GLENWOOD HIGH SCHOOL UPGRADE

CIVIL ENGINEERING DESIGN REPORT

PROJECT: Glenwood High School Upgrade
Project No: 6393

COUNCIL TRACKING SPREADSHEET AND OSD
CORRESPONDENCE

status			
scale at A1	drawn by	checked	
AS SHOWN	NKK	KEH	
project no.		drawing no.	rev.
6393		CV-0213	H

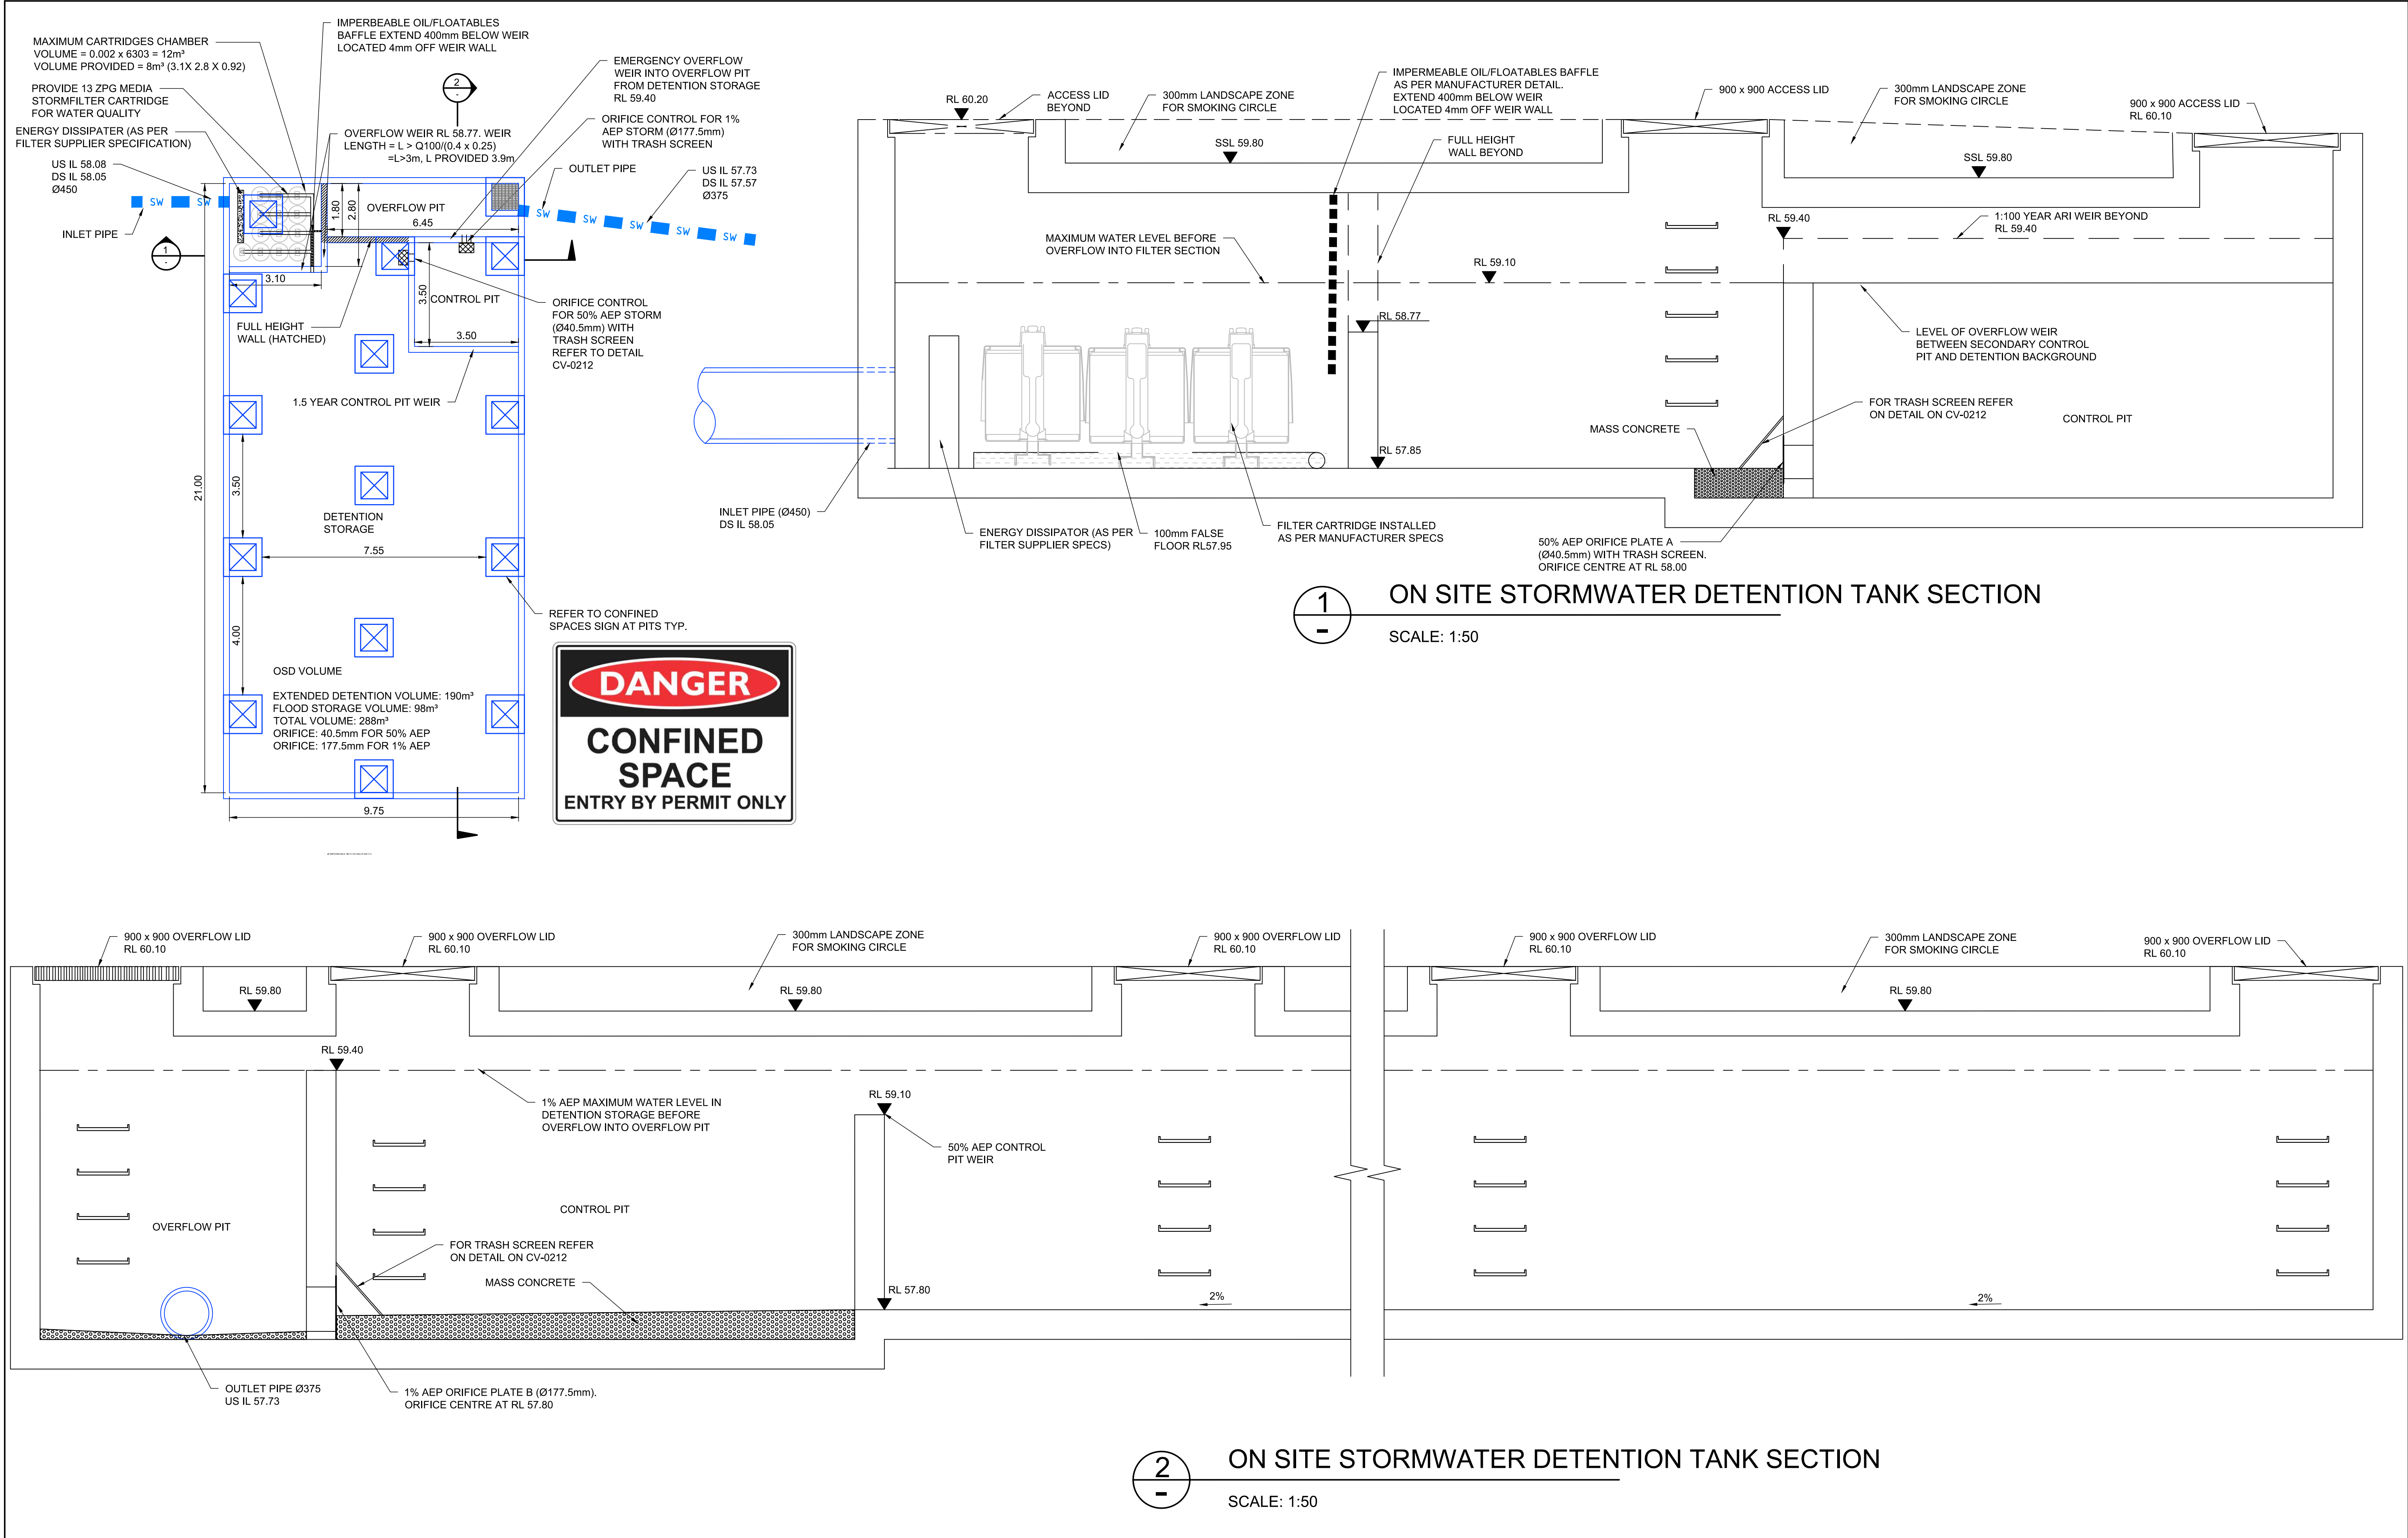
35	The design levels in the OSD tank do not match the S3QM Certificate Results or the OSD Deemed to Comply Tool Spreadsheet. Ensure consistency between the design.	OSD tank design shown on drawing CV-0212 revised to meet the OSD Deemed to comply Tool Spreadsheet. Spreadsheet provided for review. Refer to Appendix B for the OSD Deemed to Comply Tool Spreadsheet

36	Rename 100 year ARI to 1% AEP on all notes and plans.	Civil report has replaced the 100Yr ARI with 1% AEP terminology . Drawing CV-0213
37	Rename 1.5 year ARI to 50% AEP on all notes and plans.	Civil report has replaced the 100Yr ARI with 1% AEP terminology. Drawing CV-0213
38	Provide more details for the Stormfilter tank and how the overflow chamber will work.	Drawing CV-0213 shows calculations and configuration of the OSD tank which meets the requirements of BCC Engineering guide for development 2005
39	Confined space entry warning signs are to be detailed on the drainage plans adjacent to all entries into the Stormfilter Chamber in accordance with Council's Engineering Guide for Development 2005.	Signs added to drawing CV-0213
40	Provide a minimum 2% slope in the OSD storage. For larger tanks this can be in the form of a 2% cross-slope to a central "V" drain with 2% longitudinal slope along the "V" drain. Reassess tank dimensions to achieve the minimum storage volumes.	Note added to drawing CV-0213 indicating V drain dn 2% tank fall

41	There are insufficient access grates for the below ground detention tanks. Access grates to the below ground detention tank must be a minimum 900 mm by 900 mm and are positioned such that the maximum distance from any point in the tank to the nearest grate is not greater than 4 m.	Additional grades added to Drawings CV-0213 and CV-0201 which meet BCC requirements for access
42	The orifice within the Discharge Control Pit is to be protected by a suitable screen. Provide Maximesh Rh3030 for orifice diameters 150 mm or less with a minimum area of 50 times the orifice area and Weldlok F40/203 for orifices 150 mm diameter or more with a minimum area of 20 times the orifice area.	Trash screen detail added to drawing CV-0212
43	On the tank plan view, provide separate dimensions for the OSD tank and Stormfilter Chamber.	Dimensions added to drawing Drawing CV-0213 indicating chamber sizes
44	Provide a sealed impermeable baffle, or hood set 250 mm upstream of the Stormfilter weir and extending from the sealed underside of the tank to 400 mm below the top of the weir for the 690 mm Stormfilter cartridge to, to contain floatables including oil. The Stormfilter weir level is to be set 770 mm above the false floor.	Drawing CV-0213 shows calculations and configuration of the OSD tank which meets the requirements of BCC Engineering guide for development 2005. Drawing CV-0213 now shows the baffle as required for the stormwater tank

62	Allow for a 10% loss in rainwater tank size volume in MUSIC to that shown on the design plans. e.g. where a 50kL tank is modelled, construct a 55kL tank.	Rainwater tank size has been corrected to be 55kL. Refer to Section 6.1.4 of the civil report and also refer to information shown on drawing CV-0201.
63	Ensure that the areas draining to surface inlet pits with OceanGuards match the engineering plans.	Drawing CV-0201 updated with surface inlet pits collecting surface flows, which matches the catchment plan drawing CV-0200. Litter baskets noted in the pit schedule on drawing drawing CV-0001. Oceanguard detail provided on drawing CV-0212
64	Ensure that Blacktown Council's specific MUSIC modes are used for the total development area draining to the devices.	MUSIC model updated with BCC specific nodes for analysis. MUSIC model provided for review
65	The minimum Stormfilter chamber area is to be No. of Cartridges x 0.177 m2/cartridge excluding the area of the weir.	Stormfilter chamber size revised with weir dimensions shown on drawing CV-0213

66	Ocean Protect has advised that the maximum storage permitted below the Stormfilter weir to ensure effective operation of the filter cartridges is limited to an equivalent volume derived from 2.0 mm of rainfall (20 m3/Ha) without losses, falling over the site area that drains to the Stormfilter chamber (ignoring any bypass area).	Stormfilter chamber size revised with weir dimensions shown on drawing CV-0213
67	When calculating the area of detention for Stormfilters, the design area for MUSIC is the area of the cartridge bay, less the area of the weir, less 0.177 m2 per cartridge. The detention depth is the height of the Stormfilter weir above the filter false floor (i.e. the cartridge height plus 80 mm) and the low flow pipe diameter is determined from the combined cartridge flow at the Stormfilter weir height assessed as orifice flow. A spreadsheet is available from Ocean Protect.	Cartridge bay has been sized correctly using Oceaprotects spreadsheet with dimensions added to drawing CV-0213
